Ref: 301015-02585

2nd October 2012

ANIMAL WELFARE LEAGUE NSW SITE – REVISED DEVELOPMENT LAYOUT REVIEW OF FLOOD IMPACTS

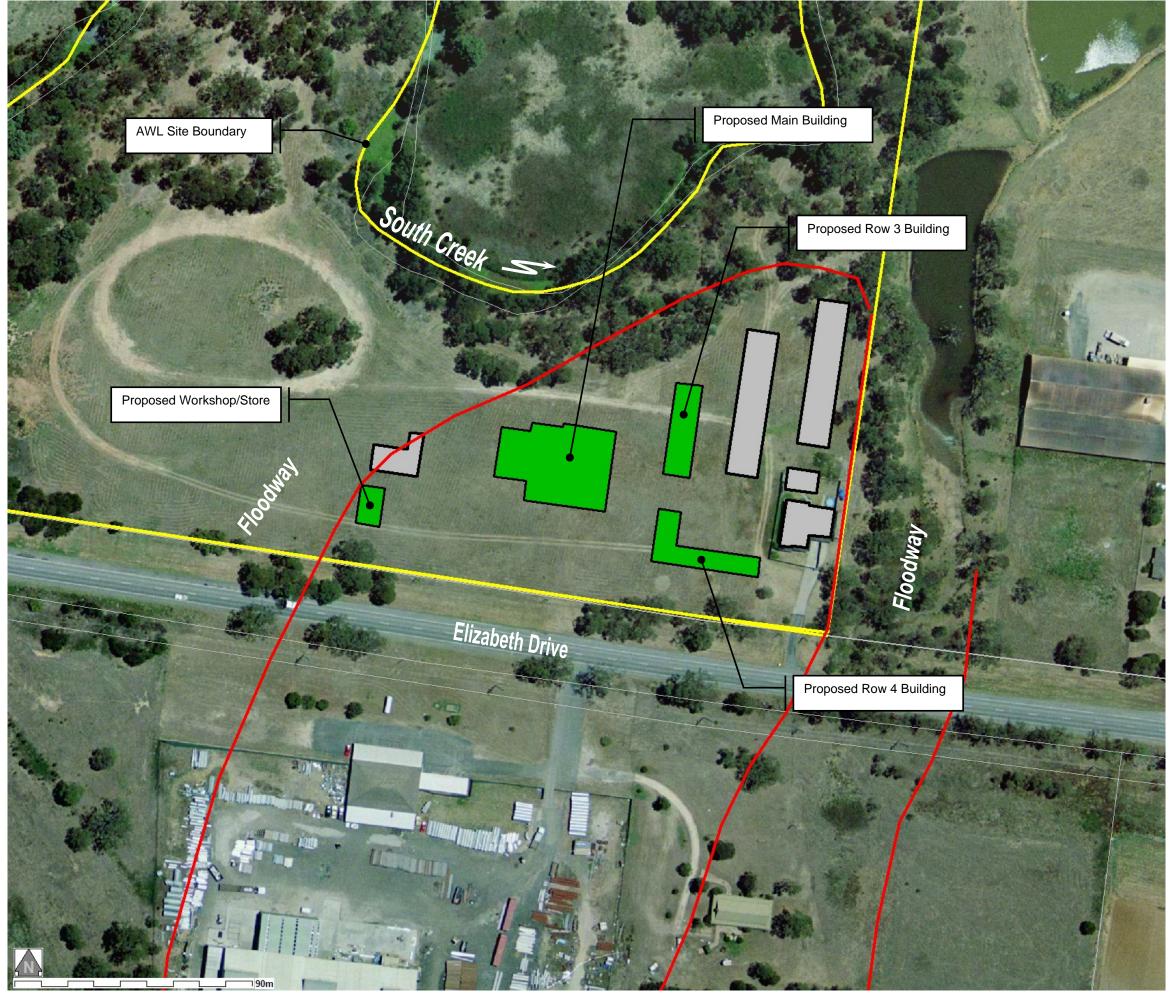
The revised layout (*refer* **Figure 1**) has been configured to be outside of the floodway corridor. It is generally similar to the previous layout at the eastern section of the site; however, with a reduction in length of the proposed Row 3 and relocation of proposed Row 4 to the south of the other rows. The workshop/store has also been relocated to the south of the existing *'Surrender'* building.

In terms of the potential impacts that the revised layout may have on local flood characteristics, it is expected that the overall extent of impacts will be reduced compared to that previously predicted (*refer* **Attachment A**). The addition of Row 4 approximately 21 metres from the Elizabeth Drive reserve is expected to result in flood level impacts on the south side of the structure during the 100 year ARI event. Similarly, the proposed workshop/store building may also create located flood level impacts immediately upstream from the structure. However, as was the case for the previous layout, flood level increases would be limited to the northern side of the Elizabeth Drive road reserve.

As per the figure in **Attachment A**, an increase in flood level of 0.3 metres would still be more than 0.7 metres below the minimum surface level of Elizabeth Drive and therefore, would not manifest as any additional flooding across the roadway. The revised development layout is expected to have similar or less impacts than that shown in **Attachment A**, because the proposed buildings are now located outside of any flow path that is now classified as floodway corridor.

The impact on flow velocity would be to reduce velocities on the upstream/south side of the proposed buildings. There may be localised increases in velocity as waters flow between buildings, but similar to flood modelling results for the previous layout, it is expected that they would be contained within the AWL site.

Accordingly, the revised development layout (*Option 3A*, *shown in Figure 1*) for the Animal Welfare League NSW site at Elizabeth Drive is not expected to have any flood related impacts greater than those presented in WorleyParsons' September 2011 Flood Impact Assessment Report, and therefore it is considered that the conclusions in that report remain valid.
